3/4.1 REACTIVITY CONTROL SYSTEMS

Docket Number 50-346
License Number NPF-3
Serial Number 2210
Attachment
Page 20

Figure 3.1-1 Minimum Boric Acid Tank Available Volume as Function of Stored Boric Acid Concentration -- Davis-Besse 1

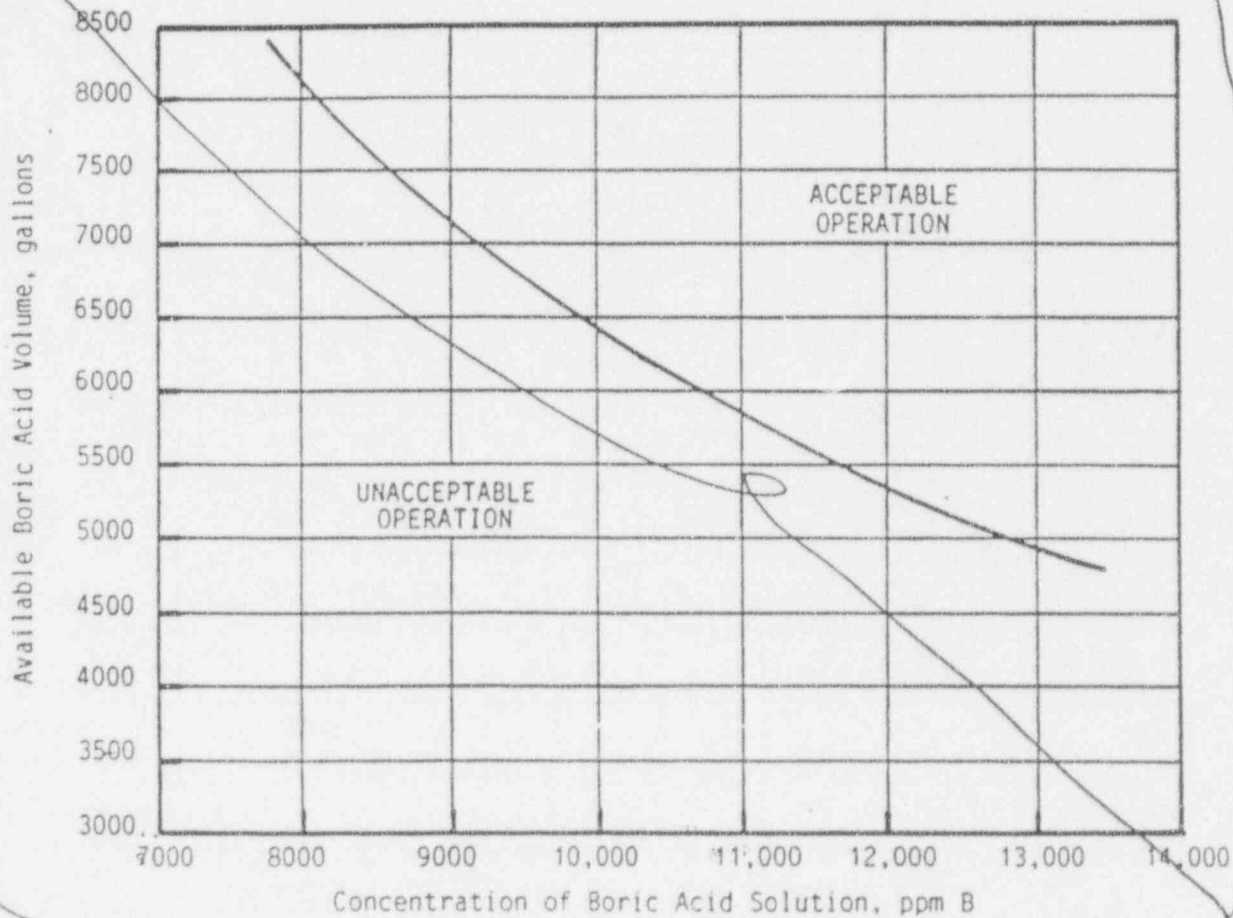
Replace with attached Figure (next page)

Replacement Figure 3.1-1

Figure 3.1-1
Boric Acid Addition System
Minimum Required Volume
as a Function of Boric Acid Concentration
Required in Modes 1-4
